Fisher Information Notice: FIN 2019-01

Subject: Mechanical Setting of Disk/Stem Taper Pins

All Fisher Type 7600, 7700, 7800, 9100, 9200, and 9500 Series Butterfly Valves that use Taper Pins to secure the Valve Shaft to the Valve Disk. This FIN does NOT apply to constructions that use straight pins or grooved straight pins.

Figure 1: Proper Staking - Pin surface is slightly below disk surface and disk material is staked over the top of the pins

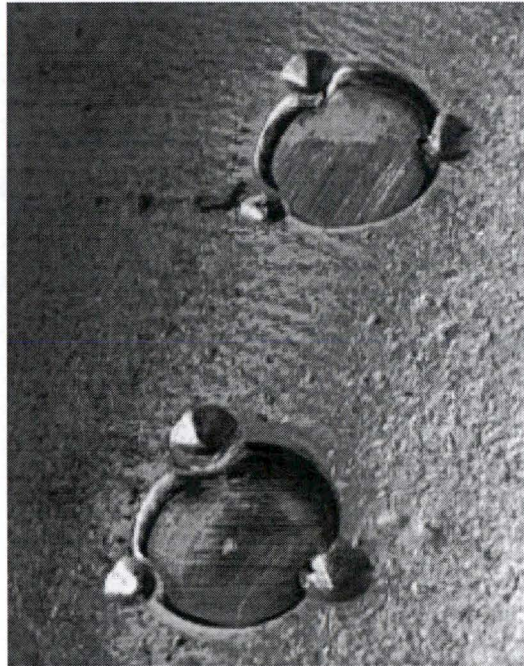
A review of the assembly showed that the pins had been ground flush with the surface of the disk and then staked in three places. However, in order to properly secure the pins in place, the

surface of the pins must be below the surface of the disk prior to final staking and the disk material must then be deformed to roll over the edge of the pins. Previous guidance did not adequately describe the need to deform the material over the pin heads. As a result, Fisher has reviewed and revised the instruction procedure for clarity. The revised instruction on Mechanical Setting of Disk/Stem Taper Pins can be found below. Additionally, the below image shows one example of proper Taper Pin staking.

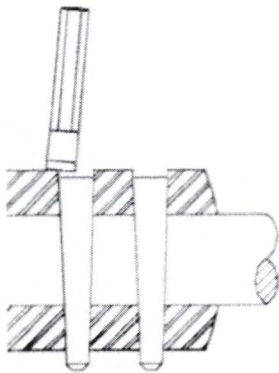
Stake the pins by deforming disk material in three locations from the circumference of each pinhole over the pins

1. Install the disk and shaft into the valve body.
2. Insert the pins into the larger end of the pin holes. Without driving the pins in with a hammer, mark the match-line between the pins and the disk on the surface of the pins.

3. Remove the pins and grind the top of the pins down to the marked match-line
4. Reinsert the pins into the larger end of the pin holes. Drive with a hammer to seat the pins. The surface of the pin should be approximately 1/8" below the surface of the disk. Additionally, the smaller end of the pins should extend past the surface of the disk on the smaller end of the pin holes.

5. To stake the pins, deform the metal at the outer perimeter of the pinholes in three locations to secure the pins inside the disk. Ensure that disk material has been deposited over the pins in order to prevent them from slipping out. Additionally, ensure that the disk material is deformed deep enough to contact the top surface of the pins.

6. For elastomer-lined valves, consult the appropriate product literature for instructions on coating the taper pin with sealant. The pins should be coated with a thin, uniform film of sealant prior to installation.
